Subject Site Plan Review MSAD # 51 Amendment re: Portable Classrooms

RE: MSAD 51 – Mabel I. Wilson Elementary School + Greeley Middle School Modular Classroom Additions
Site Plan Review- Response to Peer Review Comments

On behalf of MSAD 51, we are pleased to provide the following responses to Peer Review comments by Dan Diffin of Sevee & Maher dated April 13, 2023:

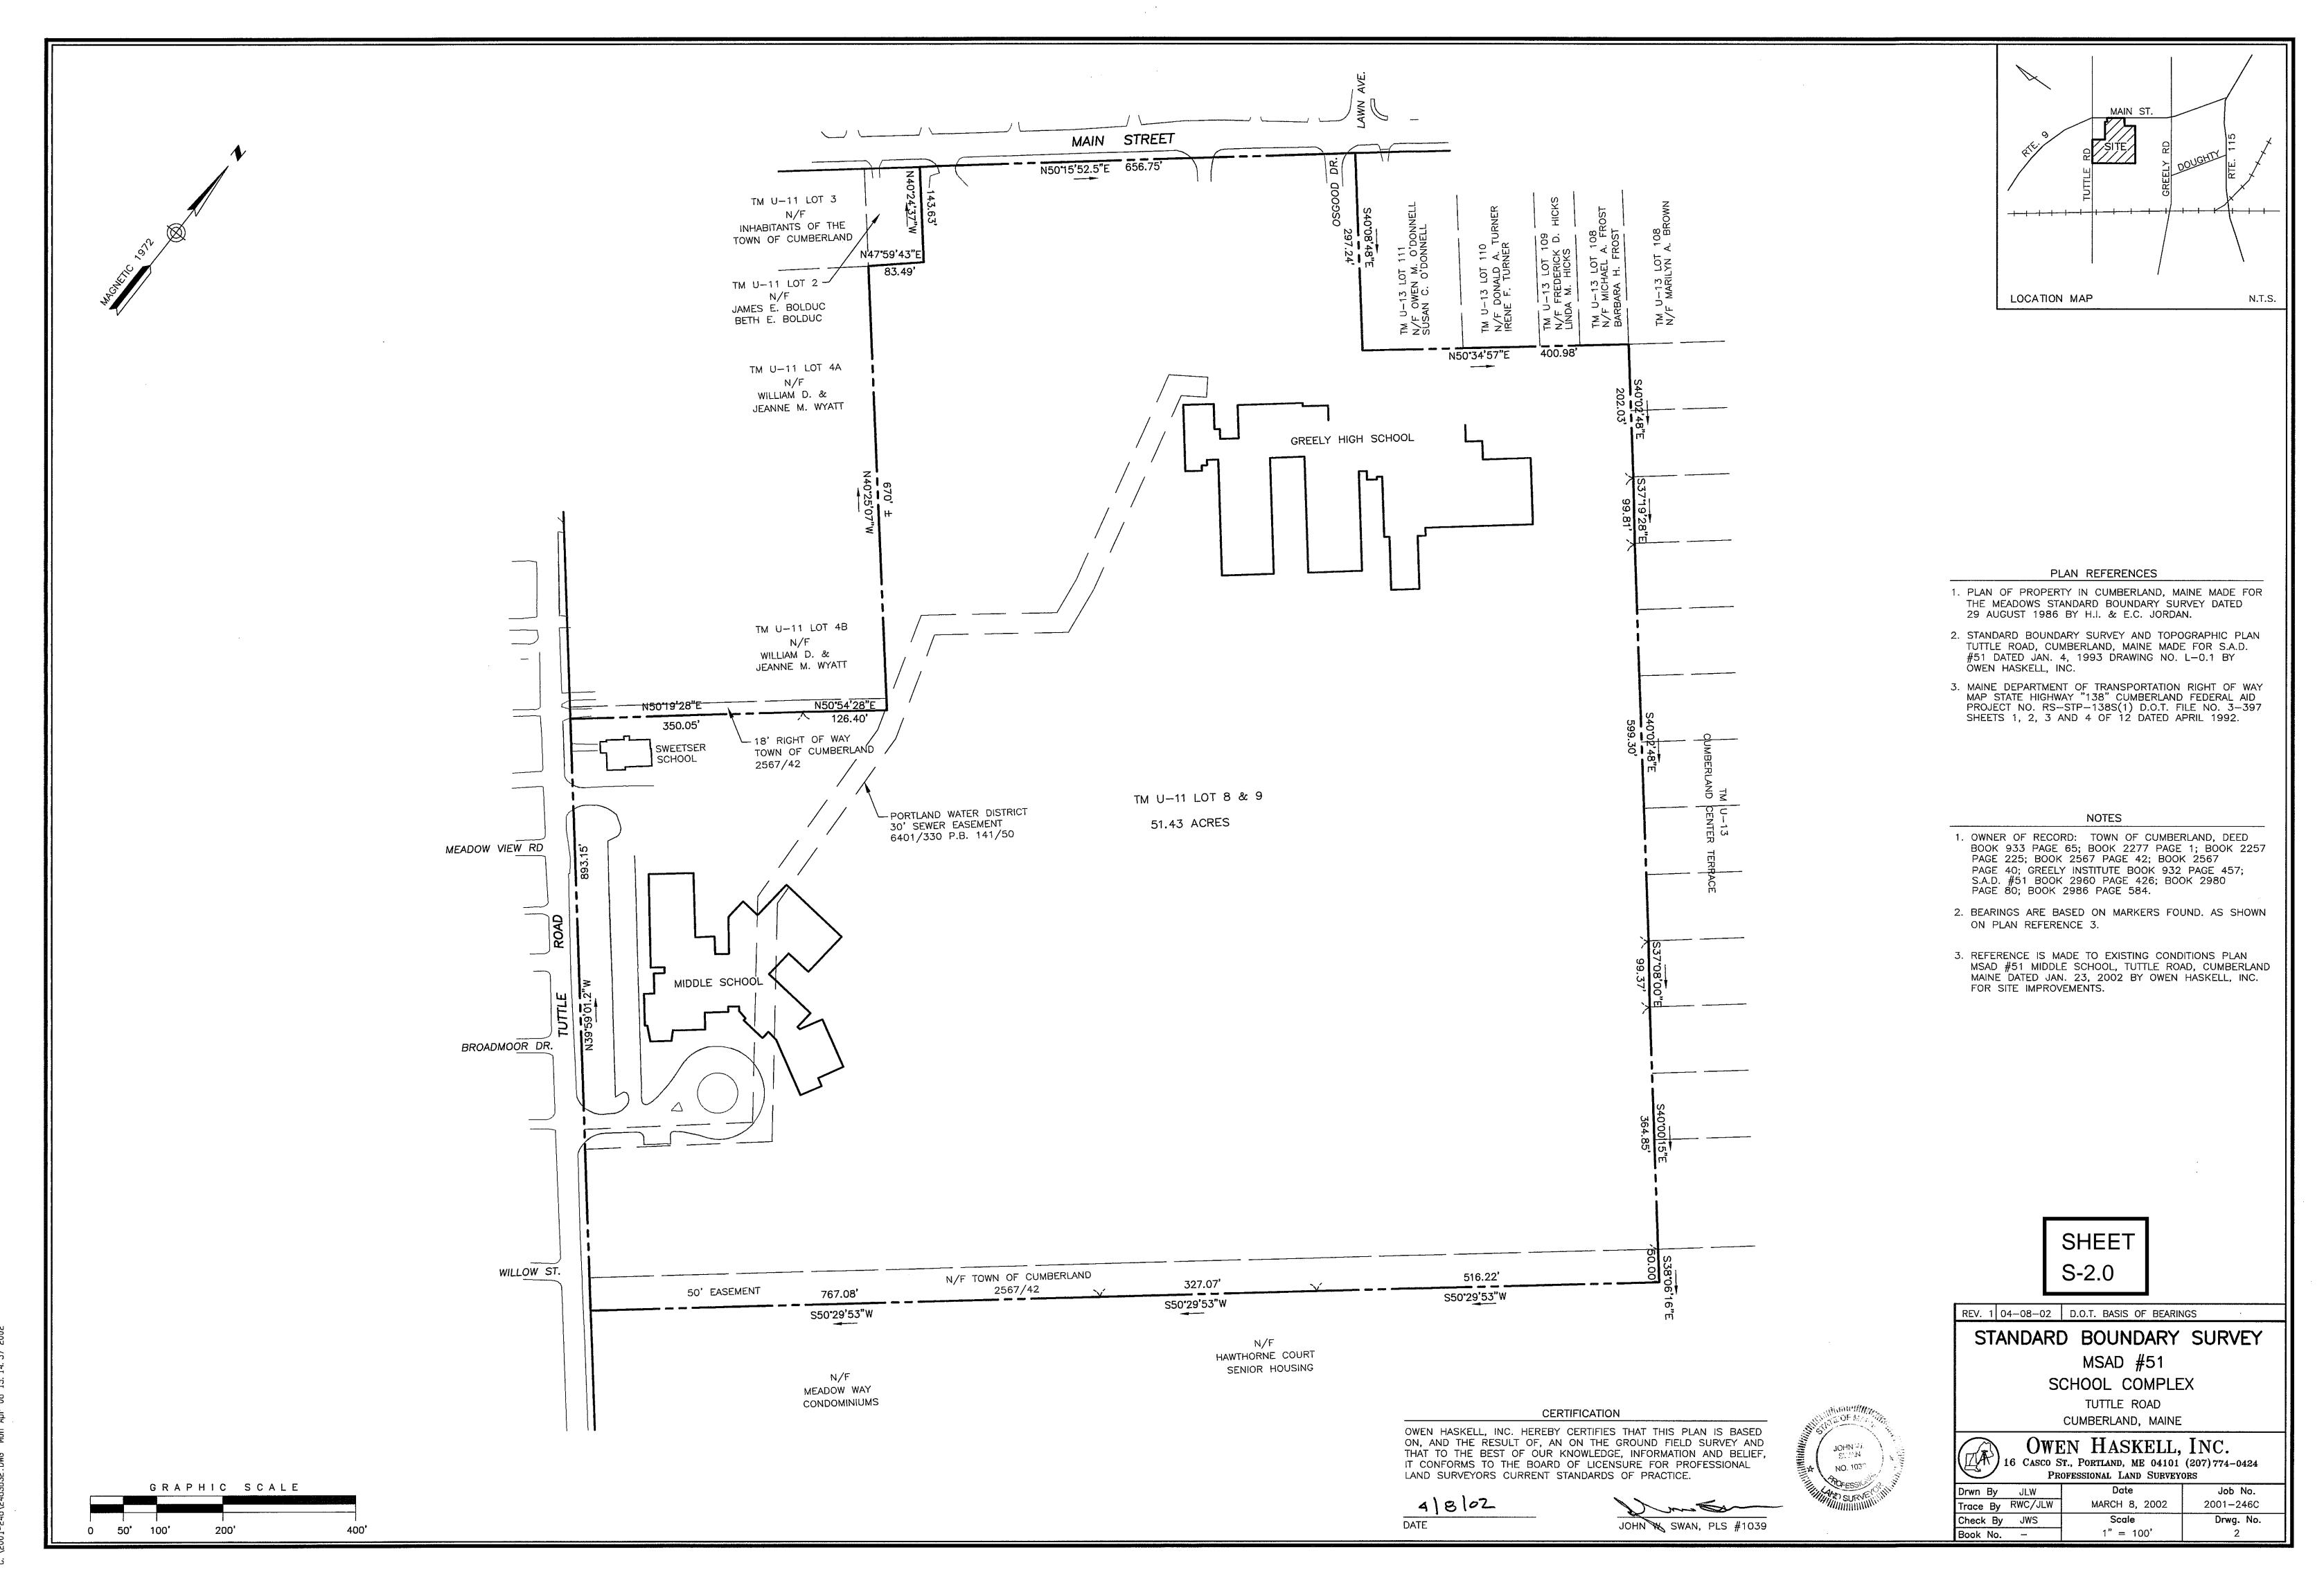
1. Please provide details for the proposed water quality treatment measures including the roof drip strip filters and bioswales to demonstrate compliance with MEDEP Chapter 500.

<u>Response</u>: A detail for the roof drip strip filters is attached to this letter. We note that bioswales are not proposed for this project.
